CERTIFICATE OF APPROPRIATENESS

Property: 1808 State Street, Lot 7, Block 441, Baker W R NSBB Subdivision. The property includes a historic 936 square foot, one-story wood frame single-family residence situated on a 5,000 square foot (50' x 100') interior lot.

Proposal: Alteration – *Revision*. The applicant received approval in August of 2014 to replace siding and windows on an existing rear addition. On February 11 a ‘Stop All Work’ order was issued after staff confirmed that six windows had been removed and replaced in the original house. The windows had been retained on site allowing staff to inspect their condition.

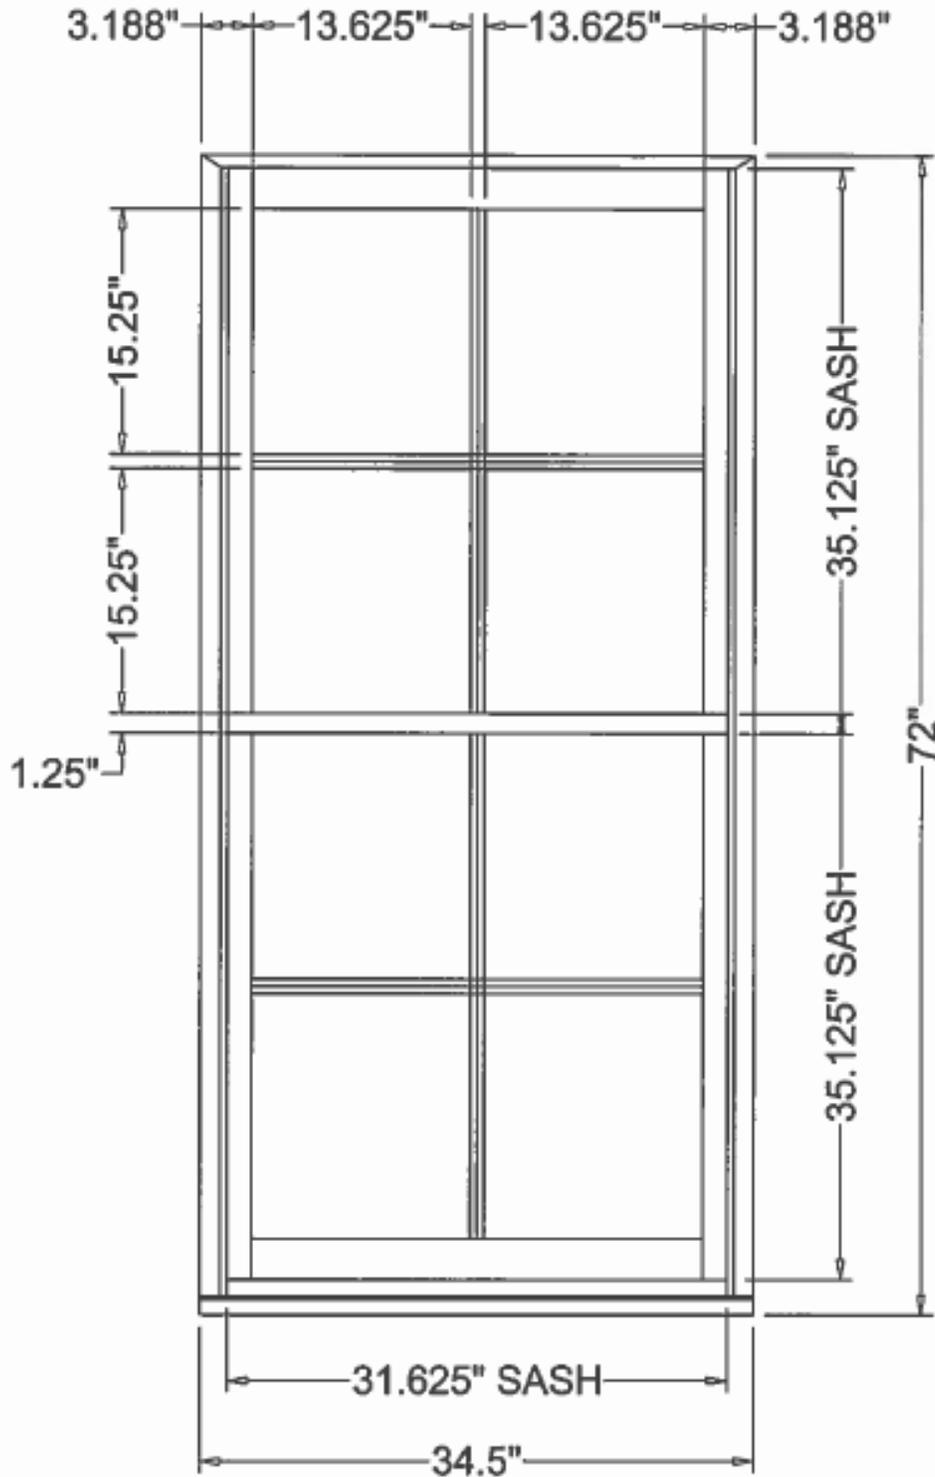
Removing an existing original window destroys significant historical and architectural material. Staff was unable to evaluate the condition of the existing window and could therefore not make an accurate assessment of its current condition. Without seeing the window, staff cannot make a determination that it is damage beyond repair. | |
